**Summit at Kemps Creek (SSD-30628110)
Comment on the Secretary's Environmental Assessment Requirements (SEARs)**

Subject: Request for SEARs for the Summit at Kemps Creek (SSD-30628110) (Penrith)

Thank you for your e-mail received on 2 July 2021, requesting input from Environment, Energy and Science Group (EES) in the Department of Planning, Industry and Environment (DPIE) on the SEARs for the Summit (SSD-30628110) (Penrith) at 706-752 Mamre Road, Kemps Creek in the Mamre Road Precinct.

From a review of the submitted documents council understands that the proposal is for a Concept masterplan and Stage 1 development, being a future State Significant Development Application (**SSDA**) and that a request has been made to the Department of Planning, Industry and Environment (**DPIE**) for the Secretary's Environmental Assessment Requirements (**SEARs**).

Figure 1 (above): Excerpt from Estate Masterplan prepared by Watson Young/Aliro

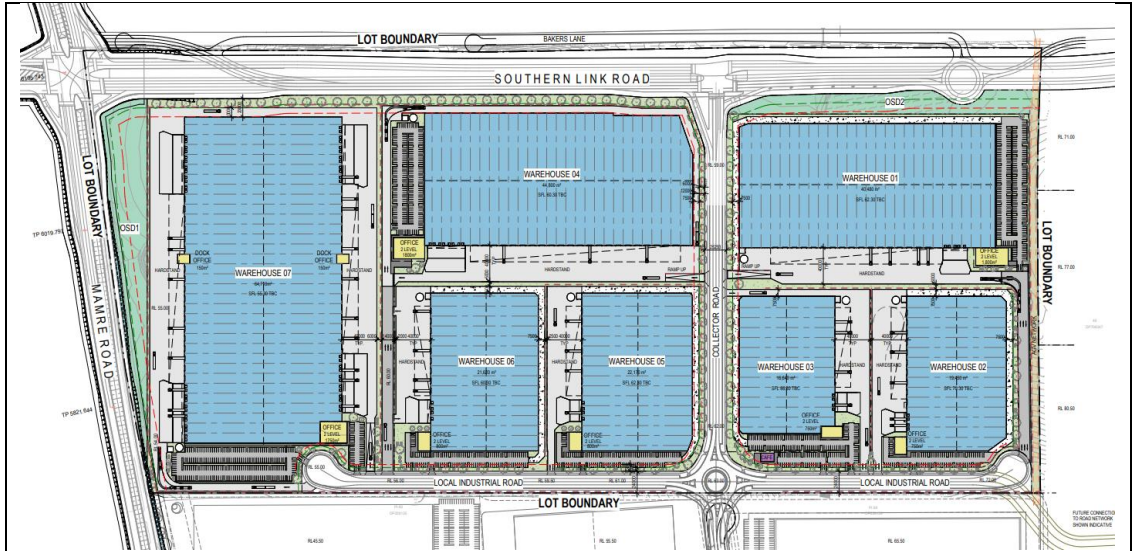
- The Estate Masterplan by Watson Young, reference 21114 – SK02, revision P6, dated 16.10.2021, has not considered the location of the future integrated freight network.

- The application and plans shall demonstrate compliance with all controls of the Mamre Road Precinct Draft DCP Clause 3.4.3 for the Integrated Freight Network.
- Plans shall include a layout of the freight network, a section as per Figure 15 and access points as per Figure 16 of the Draft DCP.

Figure 3: Excerpt from Draft Mamre Road Precinct DCP, site indicated in black.

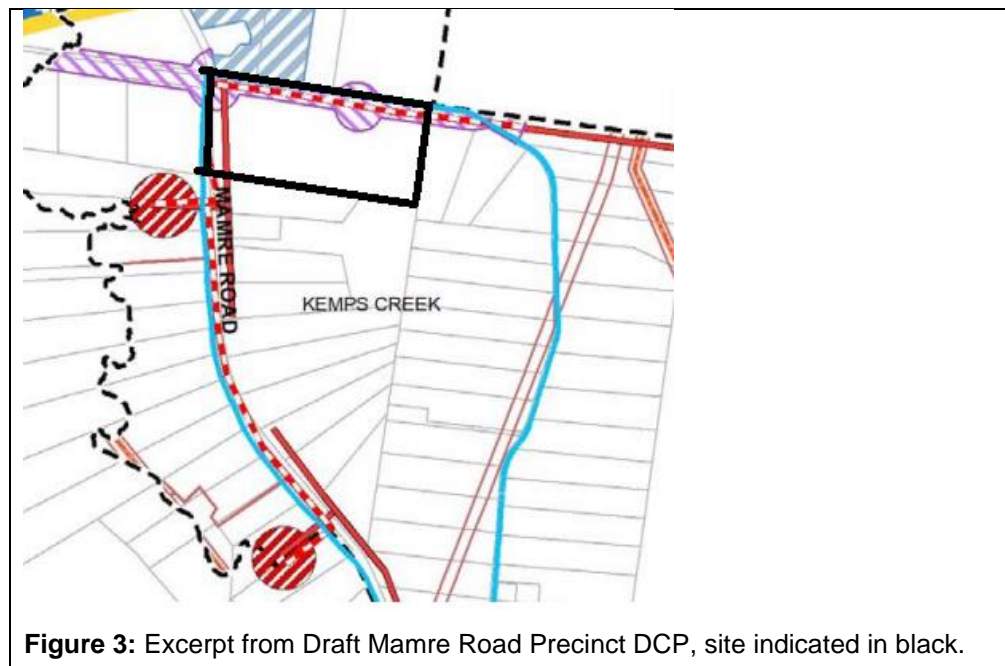
The site is located in close proximity to the identified Southern Link Road Transport Investigation Area (refer **Figure 3** below). The site also has frontage to Mamre Road which is identified for a significant upgrade and widening.

Insufficient Design Widths of Distributor/Collector Roads

The proposed design width of the Collector/Distributor road is not consistent with the required minimum roadway widths as indicated in Figure 13 of the Draft DCP. Distributor/Collector roads are required to be a minimum of 26.40m variable to 30.6m at intersections.
